My Interim Objection letter to planning application HGY/2023/2092
updated 23rd August 2023

The application Address is: 29 Riverside Road, Tottenham, London, N15 6DA
The Proposal is: a first-floor extension.

Exhibit a1

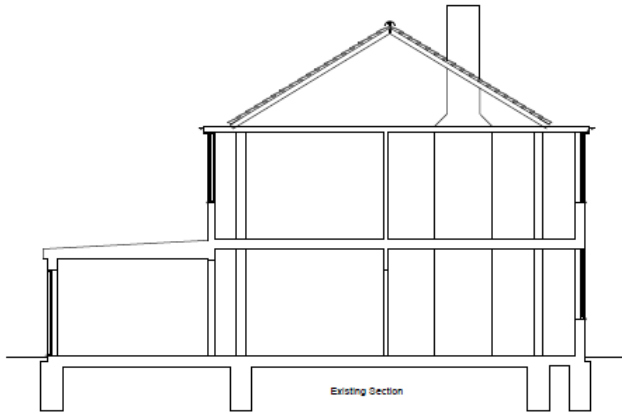
Exhibit 'a1' is the section of the existing ground floor @ 4.71 deep. the section should be the approved dimensions of **6.48m2 deep** as outlined in **Exhibit 'c'**.

Exhibit a2

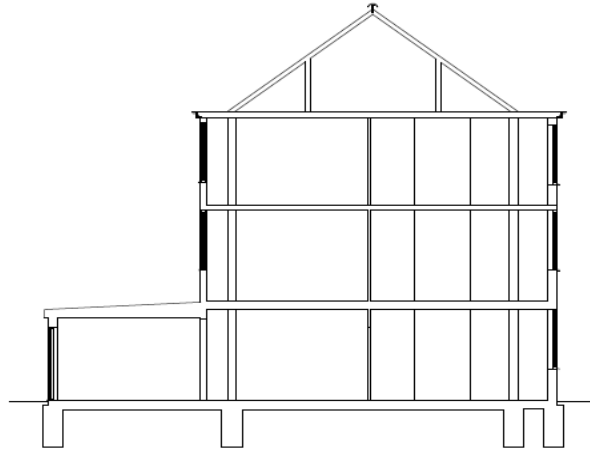
Exhibit a1 and a2 were submitted with application HGY/2023/1759. The g/f proposed extension of that application was preliminary approved on 1st August 2023. Exhibit a1 was also submitted with this application HGY/2023/2092 with the addition of the f/f extension.

Exhibit e – proposed 1st Floor Extension section

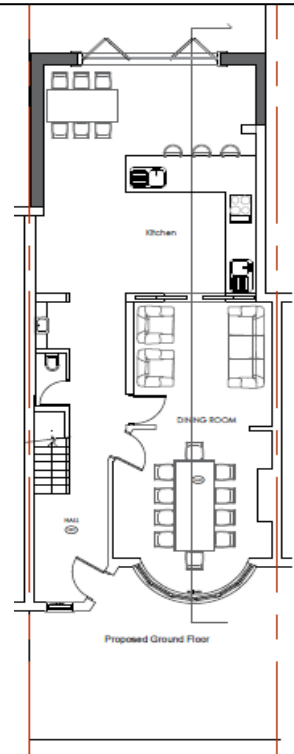
Exhibit 'e' is the section of the previous existing ground floor, the section should have outlined the **Exhibit 'c'** and the proposed 1st floor as a comparison of the bulk. The hight for both g/f and f/f is proposed at 6m. existing is 5.42m high

Exhibit d - proposed 1st Floor Extension

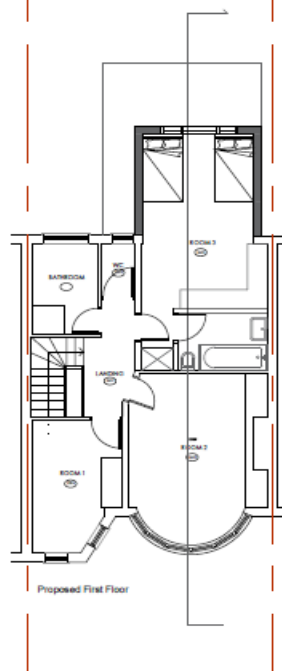
The correct proposed f/f extension as seen in **exhibit 'd'** above should have had the approved g/f plan of the new kitchen not the existing studio room

Exhibit c - approved 4m G/F extension

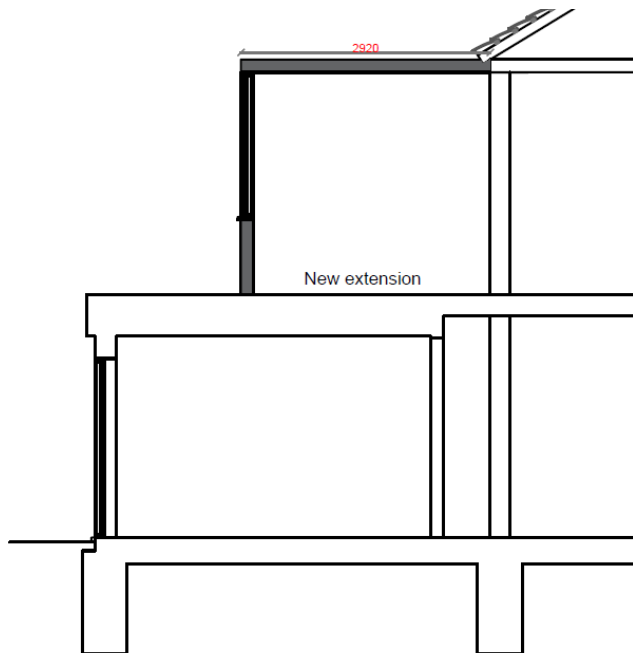
The correct approved g/f extension is seen in **exhibit 'c'** approved in previous application HGY/2023/1759) which measures **6.48m** from the rear wall of the house should have been submitted with this application (HGY/2023/2092)

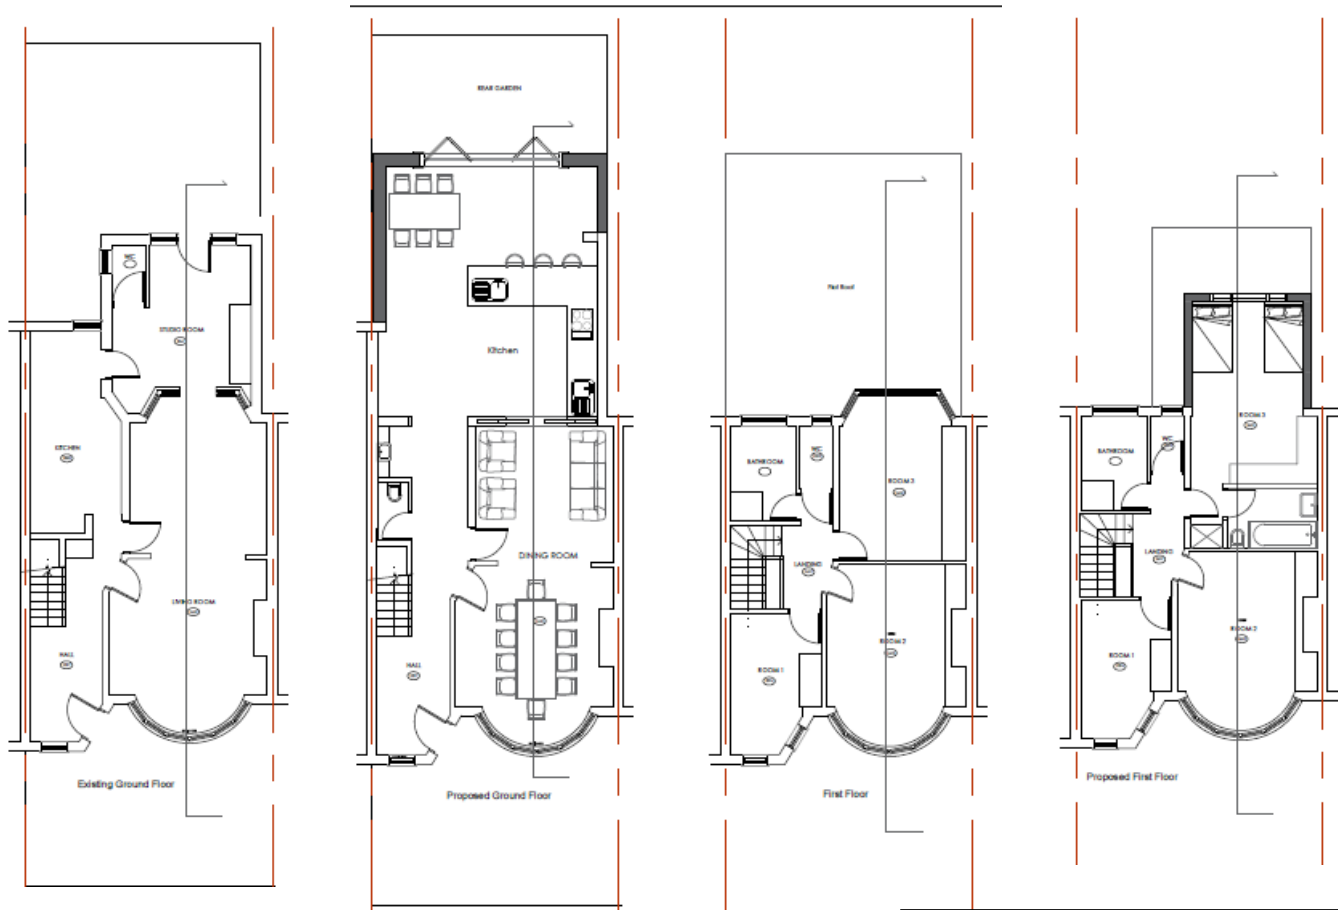
Exhibit 'a' (HGY/2023/1759 & /2092) existing ground floor extension plan @ 4.71 deep.

Exhibit 'c' ground floor approved plan is 6.48m2 deep.

Exhibit 'd' 1st floor proposed 2.92m x 3.35 out from the existing rear house wall. (Measured external = 9.78m2) to the existing bedroom according to the application the GIA is 12m2? However, the external measurements add up to 9.78m2, therefore the GIA of 12m2 is incorrect.

- 1) The application for Exhibit 'c' states that the extension is 4m. we quote: ***"which extends beyond the rear wall of the original house by 4m"***.
- 2) Exhibit c: appears to be an additional 4m extension joined on the existing rear lean 2 kitchen, (out 2.48m from the rear wall) the new extension is highlighted in grey the longer wall on the left of the plan adjoining number 27, appears to be the additional 4m run. Totalling 6.48 liner meters.
- 3) The shorter grey wall on the right of the plan is 1.77m.
- 4) The planning application indicates that the new 4m extension we quote - ***"which extends beyond the rear wall of the original house by 4m"***.

- a) The advised GIA of the additional 4m kitchen is **GIA 14m** larger than the existing retained area?
- b) The advised GIA of the additional 1st floor extension 2.92m deep x 3.35 wide (**measured external = 9.78m²**) to the existing bedroom according to the application the **GIA is 12m?** this does not add up.
- c) The visual 1st floor plan (**exhibit 'd'**) 2.92m deep compared with the existing g/f studio room (**exhibit 'a'**) which measures **4.71m the rear wall of the original house**. The outline indicated for the g/f in (**exhibit 'd'**) is the existing extension (studio room) this would indicate that from the end of the proposed 1st floor extension to the rear boundary fence there would be approximately 5.950m
- d) The 1st floor extension would cast shadow and cause loss of light in the first-floor adjacent bedroom.

- 5) The issue is that the submitted **existing g/f extension plan** (HGY/2023/2092. **exhibit 'a'** is existing **4.71m** from the rear wall of the house) and this is not the correct g/f plan that should have been submitted! In our opinion Exhibit 'c' should have been submitted.

- 6) The correct approved g/f extension is seen in **exhibit 'c'** approved in previous application HGY/2023/1759) which measures **6.48m** from the rear wall of the house this should have been submitted with this application (HGY/2023/2092).

- 7) **exhibit 'a'** (HGY/2023/1759) **is the existing g/f extension** that was submitted with application.
- 8) Why has **exhibit 'a'** been resubmitted with this new application and outlined as the Existing ground floor, when the application (HGY/2023/1759) has been pre-approved, and is a larger extension than indicated in this application?
